Erratum: “Profile Design for Misaligned Journal Bearings Subjected to Transient Mixed Lubrication” [ASME J. Tribol., 2019, 141(7), p. 071701; DOI: 10.1115/1.4043506]

Thomas Gu, Q. Jane Wang, Shangwu Xiong, Zhong Liu, Arup Gangopadhyay, and Zhiqiang Liu

Fig. 5 Impulse load is applied. Four loading cycles are shown, and the peak vertical load is 13.7 kN.

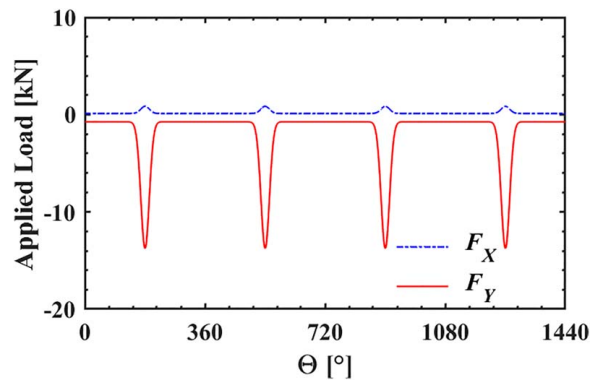
In the original publication, Fig. 5 is incorrect. The actual applied loads used for all the simulations can be found in the corrected figure below with a peak vertical load of 13.7 kN in magnitude.
